Committee of Experts on the Transport of Dangerous Goods
and on the Globally Harmonized System of Classification
and Labelling of Chemicals

Amendments of Chapter 2.17 “Desensitized Explosives”

Track change version (ST/SG/AC.10/C.3/2014/81 versus
ST/SG/AC.10/C.3/2014/2 and ST/SG/AC.10/C.4/2014/16 versus
ST/SG/AC.10/C.4/2014/2)

Transmitted by the expert from Germany

Decision logic 2.17.1 for desensitized explosives^{(b)(2)}

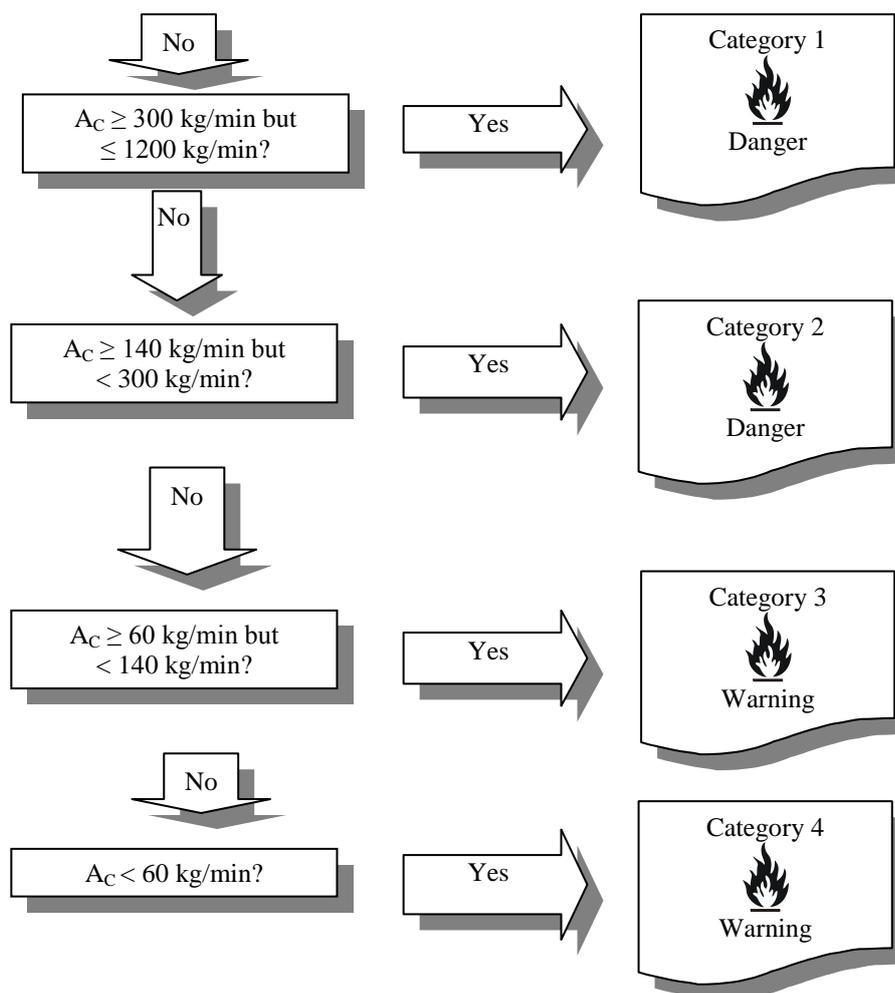
To classify desensitized explosives, data for the explosive potential and the corrected burning rate ~~has to~~ should be determined as described in Part V of the *United Nations Recommendations on the Transport of Dangerous Goods, Manual of Tests and Criteria*. Classification is according to decision logic 2.17.1.
